LOST CREEK ISR, LLC

**Re: Lost Creek Project Responses to Health Physics Comments
Docket No. 40-9068
TAC No. LU0142**

NRC and Lost Creek ISR, LLC's Detailed Discussion Summary

FIGURE 6.7-2
RADON AND GAMMA DURING OPERATIONS
 Lost Creek Permit Area
 Issued For: NRC TR Drawn By: EJS
 Issued/Revised: 03.06.08
 Drawing No: NRC-TR-5.7-2-03.04.08-EJS
 0 0.5 Miles

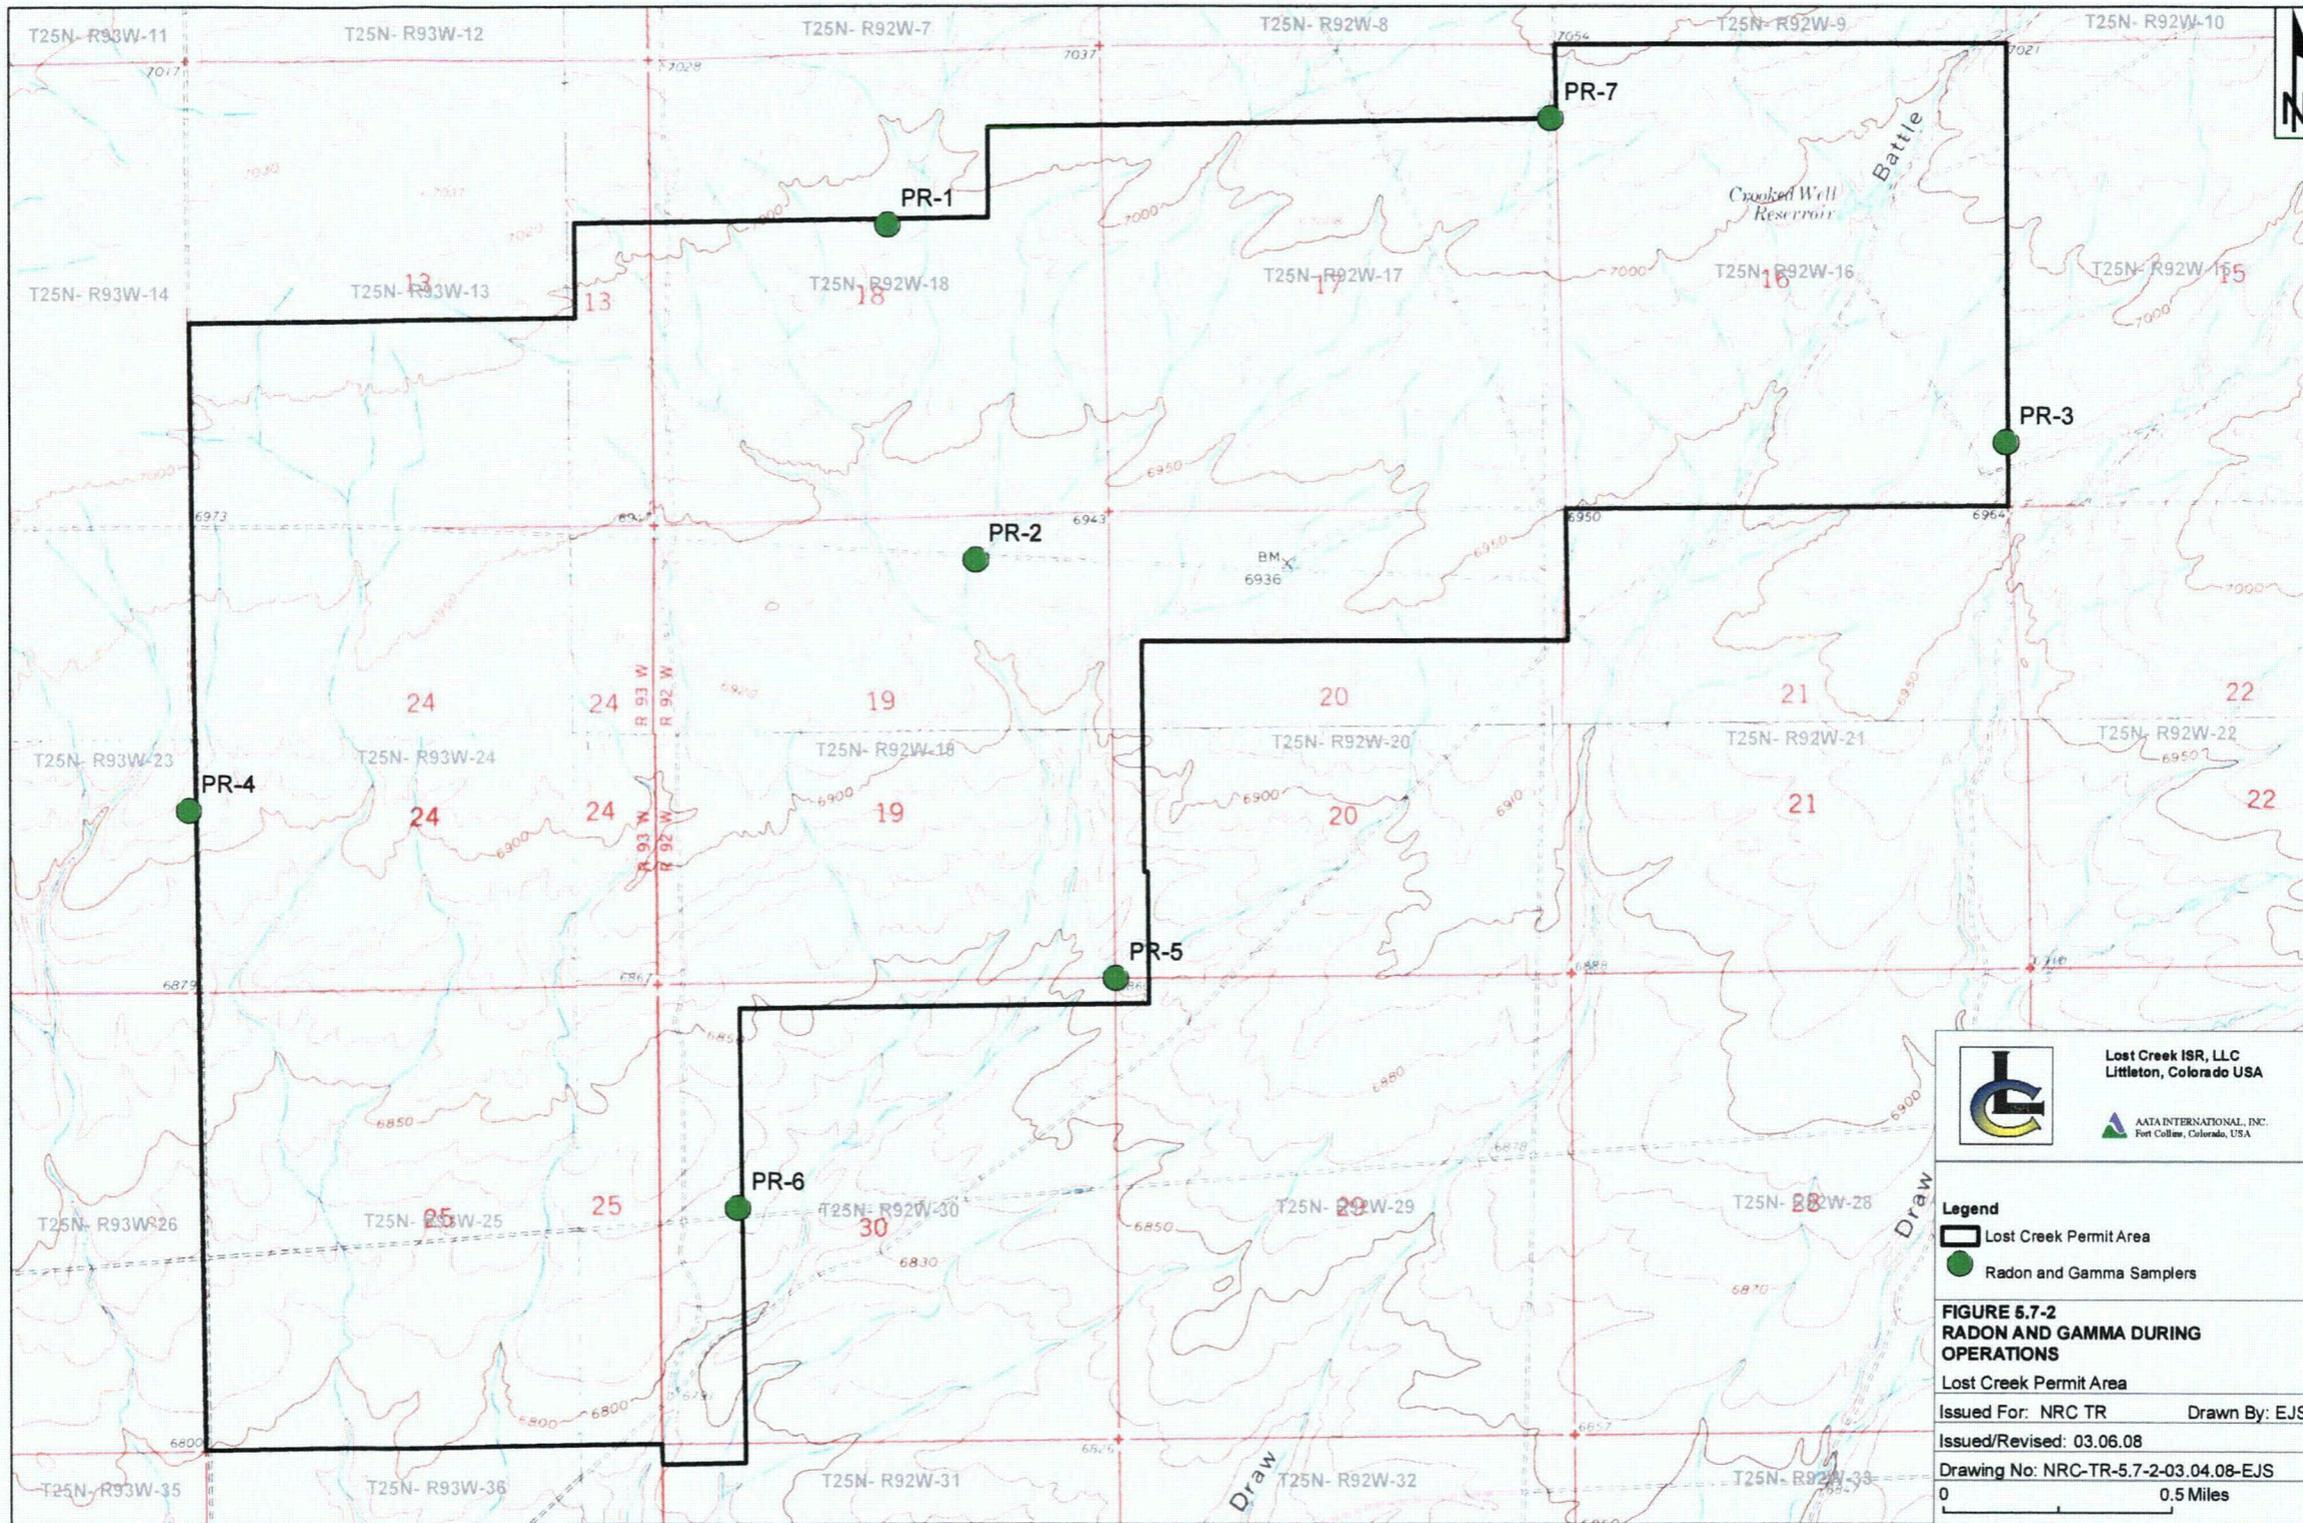
5) LCI does not address soil sampling, as recommended in RG 4.14 for an operational radiological monitoring program, and as asked RAI question 5.7.7(2). As pointed out in the question, and identified in the application, radon daughters will accumulate in soil, among other places. RG 4.14 includes Pb-210, a radon daughter, as a radionuclide to sample.

In agreement with RG 4.14, LCI will monitor radon gas and direct radiation, at the same locations as in the preoperational monitoring (Attachment 3) plus at those additional operational locations described in LCI TR Section 5.7.7 (Attachment 4). Additionally, radon gas and direct radiation measurement will also be co-located with the background HV-3 particulate air monitor, and monitors HV-2 and HV-5 (Attachment 2). HV-2 is currently located within the location of the plant, so practically it must be relocated slightly and will be repositioned just outside the fence line nearest the MILDOS maximum point discussed above. There will then be a total of eleven locations with radon gas and direct radiation measurement; five of which will be co-located with the particulate air monitors.
